CASE NO. 2020-00040

TURKEY CREEK SOLAR, LLC

RESPONSES TO BBC RESEARCH AND CONSULTING'S FIRST REQUEST FOR INFORMATION

Exhibit C

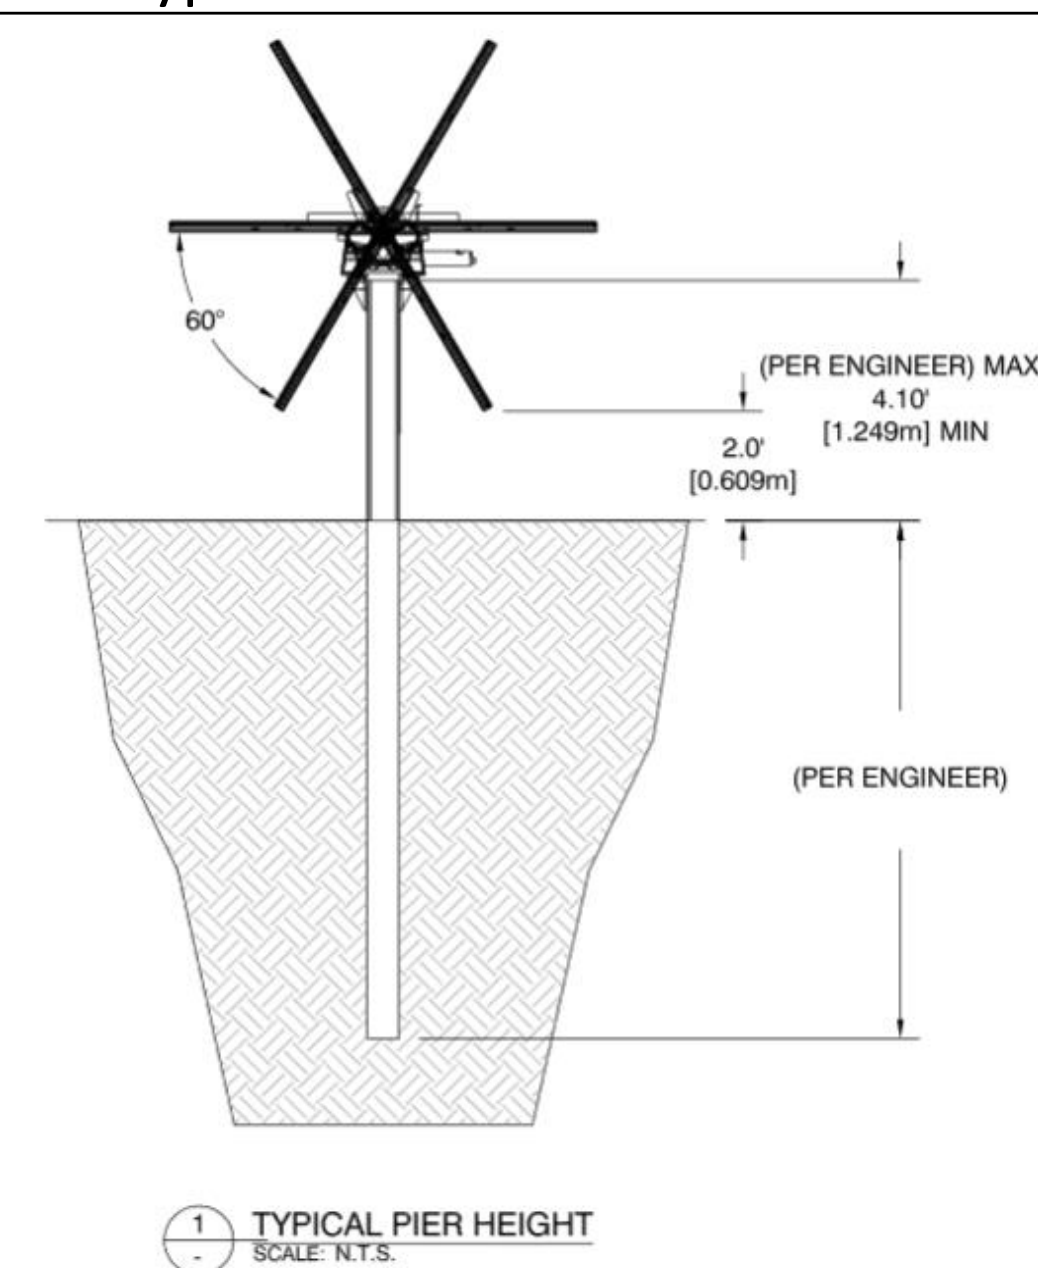
3. Exhibit C "Noise and Traffic Study" notes that "driveway access on SR 39 and US 27 would provide two points of entry to the project site." (Page 6 of Exhibit C "Noise and Traffic Study"). Apparently the second entrance is from US 27, and Exhibit C further notes that both entrances are existing paved driveways near the northernmost portion of the property, but there is no further information in the SAR regarding where the second entrance is located. **Please revise the aerial simulation provided in Exhibit E to depict this second entrance.**

Response: Please see Exhibit C for an updated layout showing the second entrance on Stanford Street (HWY 27). Additionally, a third entrance on Crab Orchard Road will be used only infrequently for maintenance vehicles, and not as a construction entrance.

EXHIBIT E: Simulation from 2 neighboring properties

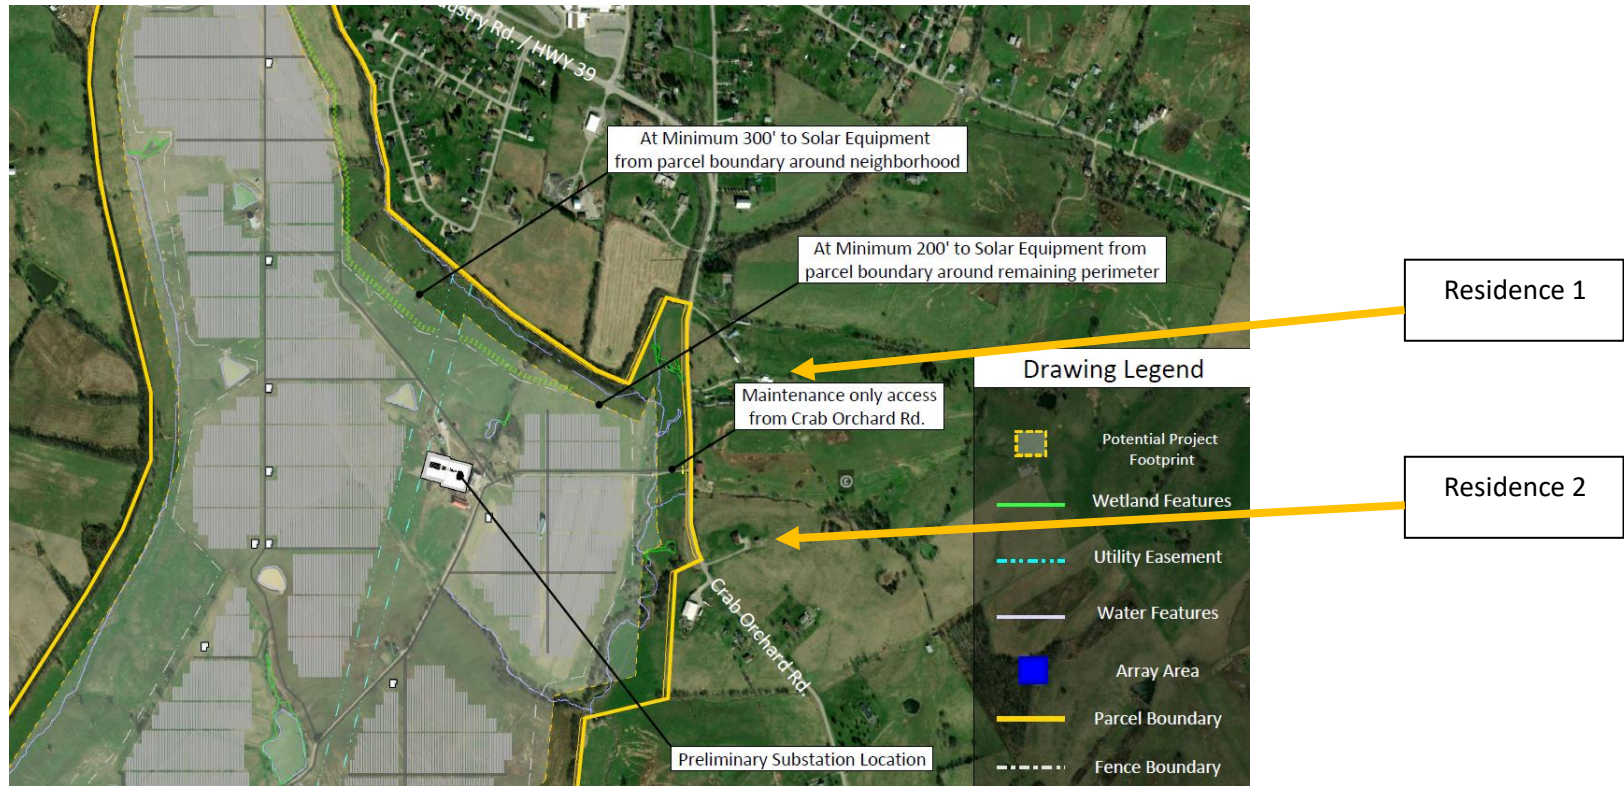
6. While none of the previous merchant power plant siting applications in Kentucky have involved commercial solar facilities, previous applicants have typically provided a visual simulation of the proposed project from sensitive receptors or key observation points. **Please provide a simulation of the future view of the proposed facility from the nearest residences or other key observation points.**

Response: Please see Exhibit E for a simulation from two neighboring properties.
